Staff Summary Report

SUBJECT: Hold a public meeting for a Development Plan Review for U.S. INDUSTRIAL FASTENERS located at 2026 East Cedar Street.

COMMENTS: Request for **U.S. INDUSTRIAL FASTENERS (PL060587)** (Kevin Blackburn, U.S. Industrial Fasteners, property owner; Brian Johns, Associated Architects, applicant) for the expansion of an existing building consisting of +/-38,562 s.f. of total building area on 21.8 acres, located at 2026 East Cedar Street, in the GID, General Industrial District and the Transportation Overlay District, including the following:

DPR07015 – Development Plan Review including site plan, building elevations and landscape plan.

SITE PLAN

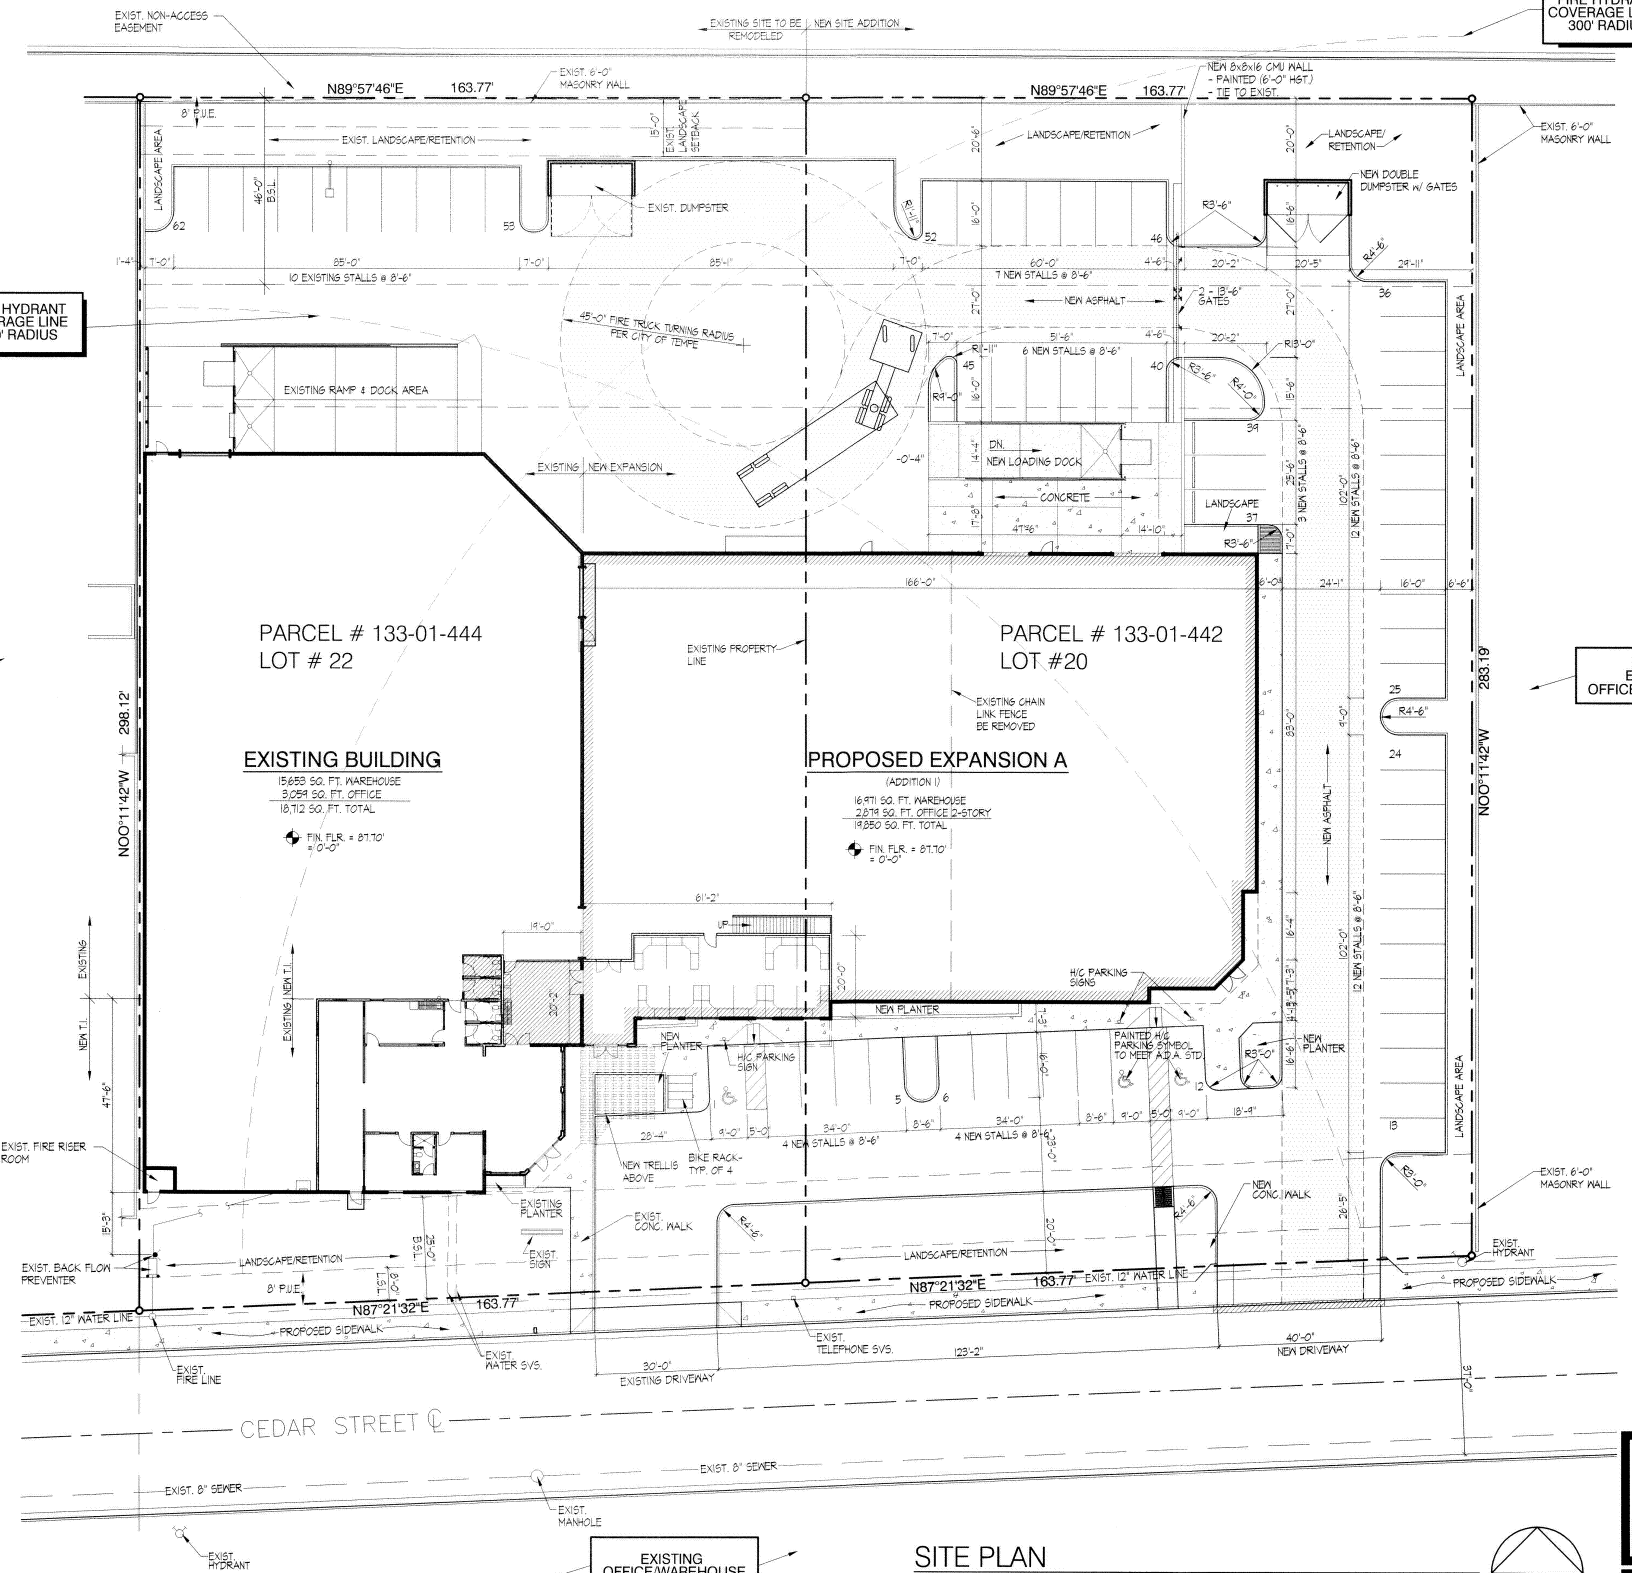
3. Provide 6'-0" wide public sidewalk along public street, or as required by Traffic Engineering Design Criteria and Standard Details.

4. Provide service yard and mechanical (cooling tower/generator) yard walls that are at least 8'-0" tall as measured from adjacent grade and are at least the height of the equipment being enclosed, whichever is greater. Verify height of equipment and mounting base to ensure that wall height is adequate to fully screen the equipment. Locate electrical service entrance sections inside the service yard, as indicated.

6. Provide upgraded paving at each driveway apron consisting of unit paving. Extend unit paving in the driveway from the back of the accessible public sidewalk bypass to 20'-0" on site and from curb to curb at the drive edges.

- Correctly indicate clear vision triangles at both driveways on the site and landscape plans. Identify speed limits for adjacent streets at the site frontages. Begin sight triangle in driveways at point 15'-0" in back of face of curb. Consult "Corner Sight Distance" leaflet, available from Development Services Counter or from John Brusky in Transportation (480-350-8219) if needed. Do not locate site furnishings, screen walls or other visual obstructions over 2'-0" tall (except canopy trees are allowed) within each clear vision triangle.

NORTH ELEVATION

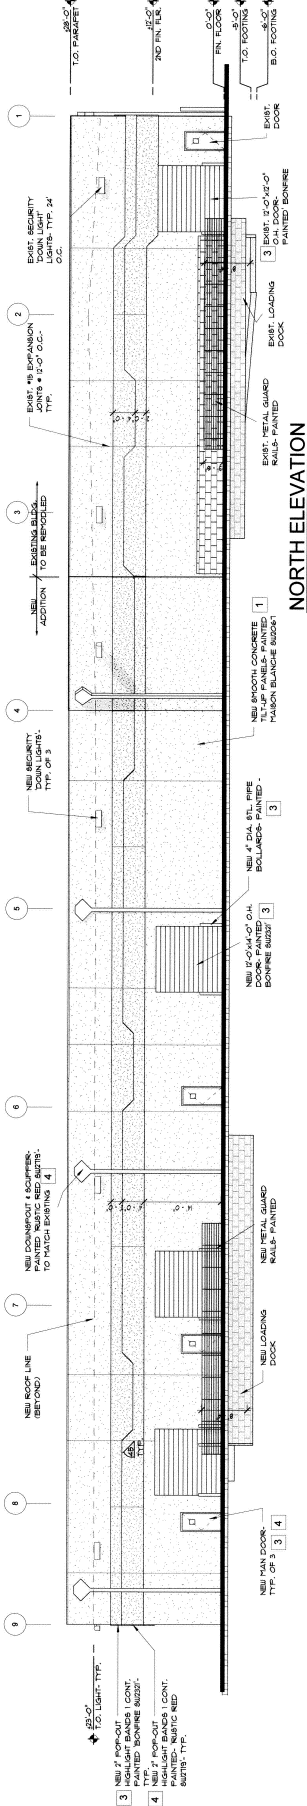
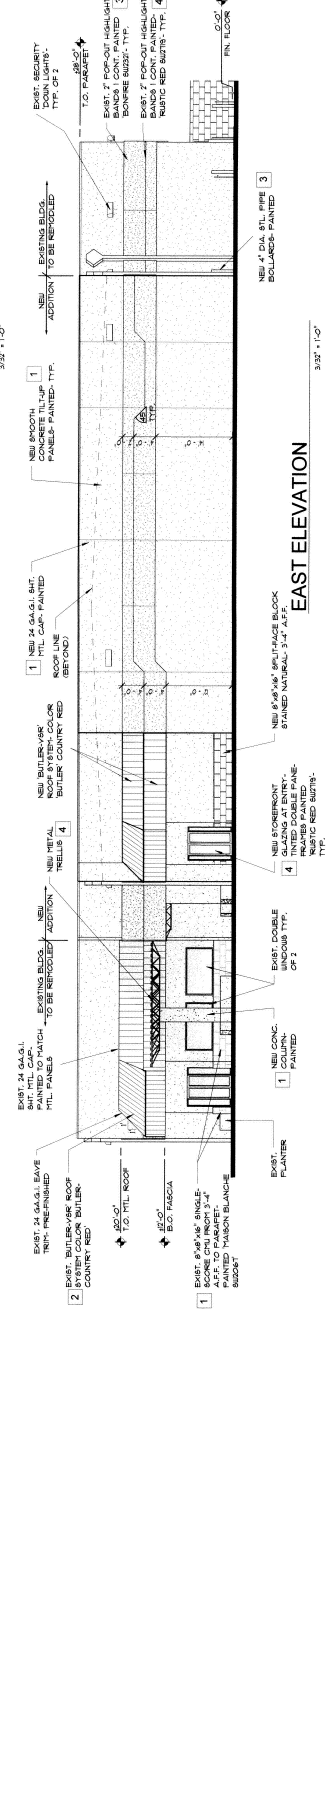
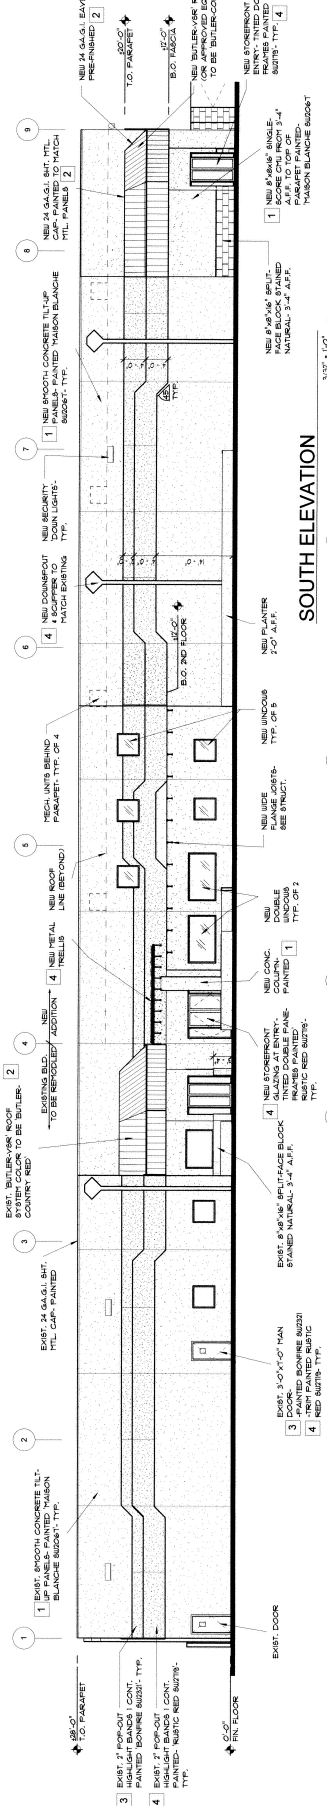
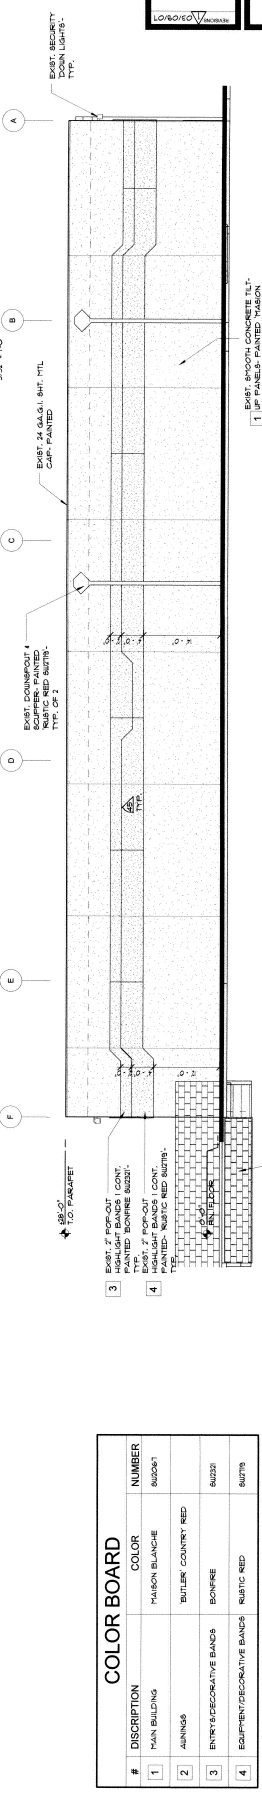
9. Provide main colors and materials with a light reflectance value of 75 percent or less. Specific colors and materials exhibited on the materials sample board are approved by planning staff. Submit any additions or modifications for review during building plan check process. Planning inspection staff will field verify colors and materials during the construction phase.

10. Provide secure roof access from the interior of the building. Do not expose roof access to public view.
 11. Conceal roof drainage system within the interior of the building. Minimize visible, external features, such as overflows, and where needed design these to enhance the architecture of the building.

12. Incorporate lighting, address signs, incidental equipment attachments (alarm klaxons, security cameras, etc.) where exposed into the design of the building elevations so that the architecture is enhanced by these elements.

13. Locate the electrical service entrance section (S.E.S.) inside the building or inside a secure yard that is concealed from public view.
 14. Exposed conduit, piping, etc. is not allowed unless a creative conduit surface design that compliments the architecture is reviewed and approved by the Development Review Commission.

19. Provide address sign(s) on all new building elevations.

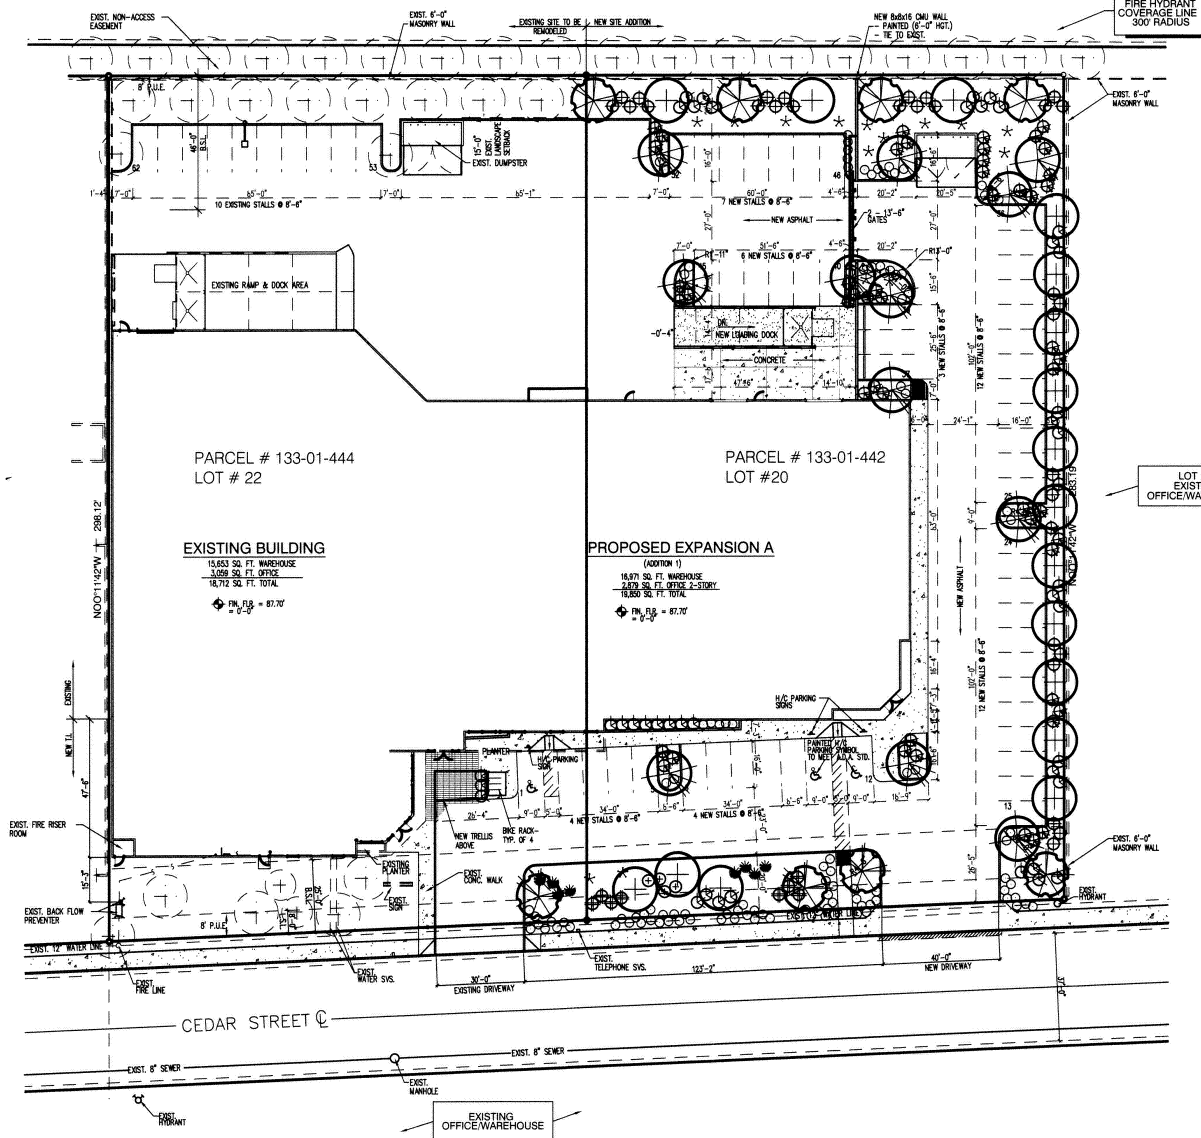
- a. Enclose backflow prevention device in a lockable, pre-manufactured cage.
 - b. Provide pipe distribution system of buried rigid (polyvinylchloride), not flexible (polyethylene). Use of schedule 40 PVC mainline and class 315 PVC ½” feeder line is acceptable. Class 200 PVC feeder line may be used for sizes greater than ½” (if any). Provide details of water distribution system.

17. Include requirement in site landscape work to de-compact soil in planting areas on site and in public right of way and remove construction debris from planting areas prior to landscape installation.

18. Top dress planting areas with a rock or decomposed granite application. Provide rock or decomposed granite of 2” uniform thickness or less. Provide pre-emergence weed control application and do not underlay rock or decomposed granite application with plastic.
